Airworthiness Directives; Eurocopter France Model AS355E, F, F1, F2, and N Helicopters

ACTION: Notice of proposed rulemaking (NPRM).

Eurocopter France: Docket No. 2003–SW–10–AD. Revises AD 2003–21–09, Amendment 39–13344.

Figure 1

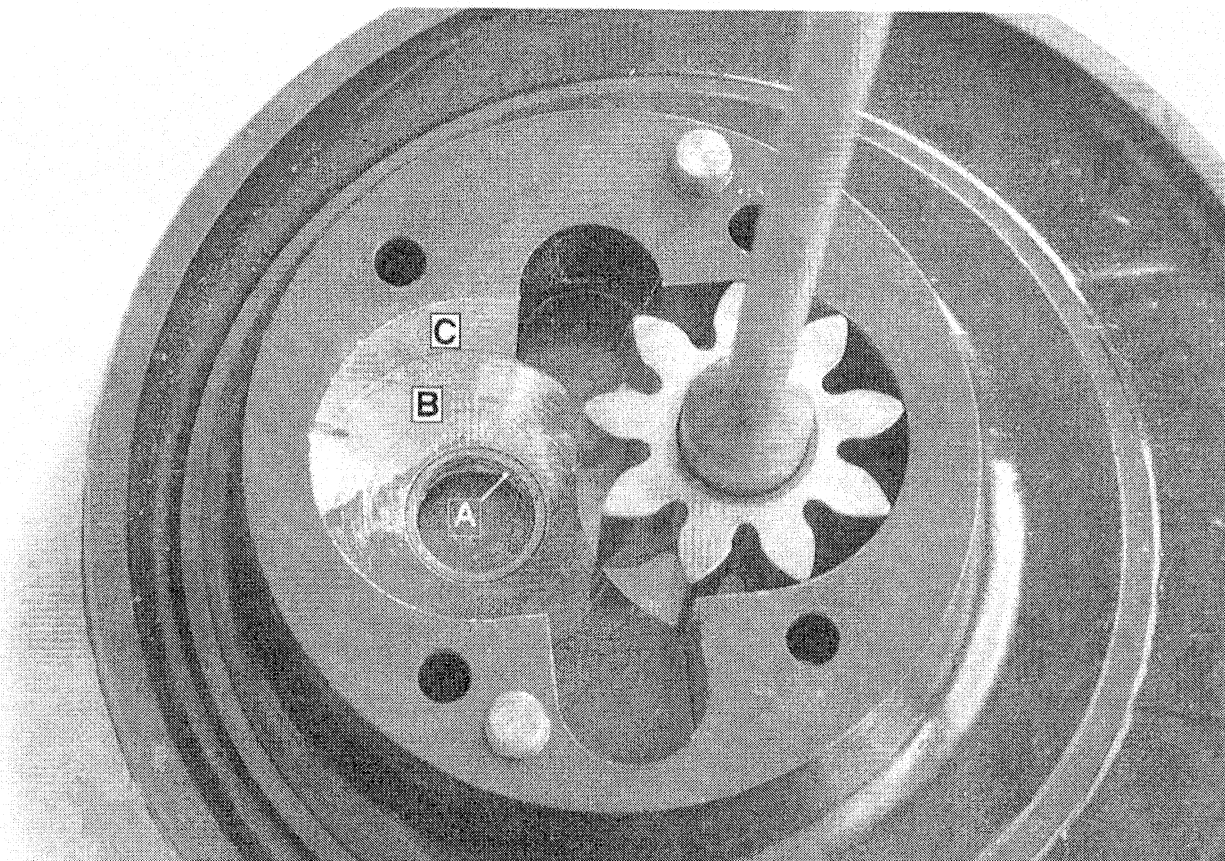
(d) While inspecting the pump, if you find any of the following, replace the MGB and the pump with an airworthy MGB and pump before further flight:

- (1) Crank pin play,
- (2) Out of round bronze bushing (A of Figure 1),
- (3) Offset of the driven gear pinion,
- (4) Metal chips, or
- (5) Wear (C of Figure 1).

Note 2: If wear is present in the B area only as depicted in Figure 1, replacing the MGB and the pump is not required.
